MEMORANDUM

SUBJECT: Heritage Permit Application
1 Church Lane, Thornhill Heritage Conservation District
HE 20 126092

Photograph of damage done to existing fence

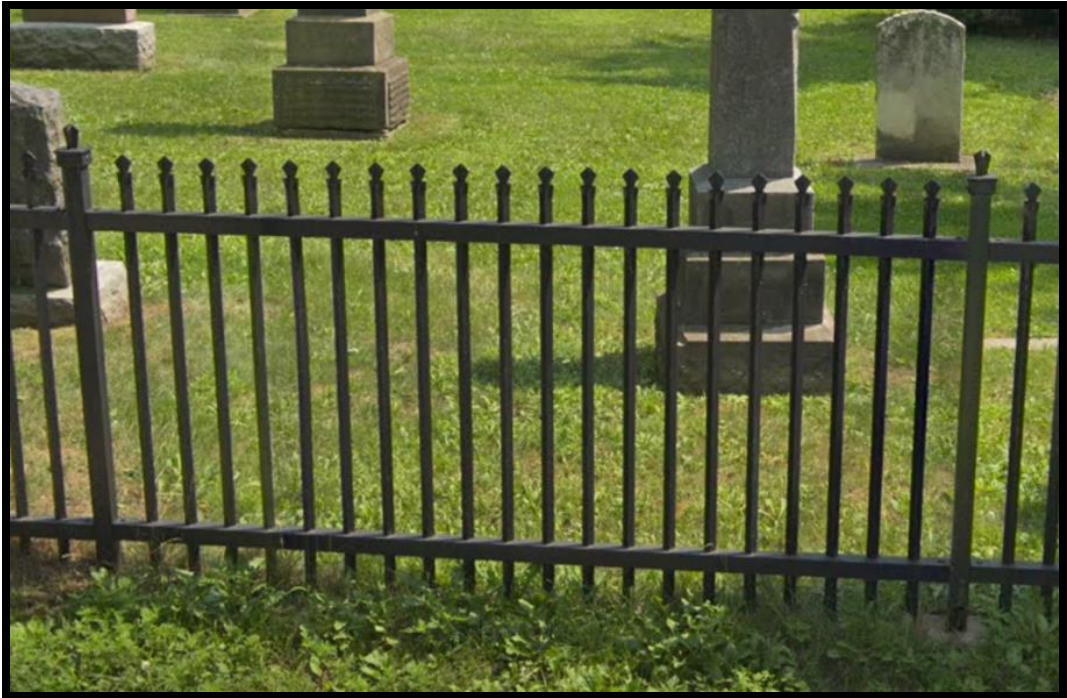
- The City has submitted a heritage permit seeking to install a new 4 ft. high wrought iron fence and gates after the existing wrought iron fence was badly damaged at the intersection of Church Lane and John Street by an automobile.

- The proposed new wrought iron fence appears to be an acceptable solution as it maintains the historic character of the Thornhill Cemetery, and because the existing fence is a 20th century wrought iron fence. The particular details of the existing fence are not as significant as they would be if the fence were from 1867 when the cemetery was first established;
- Therefore staff recommends supporting the proposed new wrought iron fence and that final review of the heritage permit for the new wrought iron fence and gates at the Thornhill Cemetery be delegated to Heritage Section staff.

THAT Heritage Markham has no objection from a heritage perspective to the proposed new wrought iron fence to replace the damaged existing wrought iron fence at 1 Church Lane;

AND THAT final review of any matters related to the proposed new wrought iron fence be delegated to Heritage Section staff.
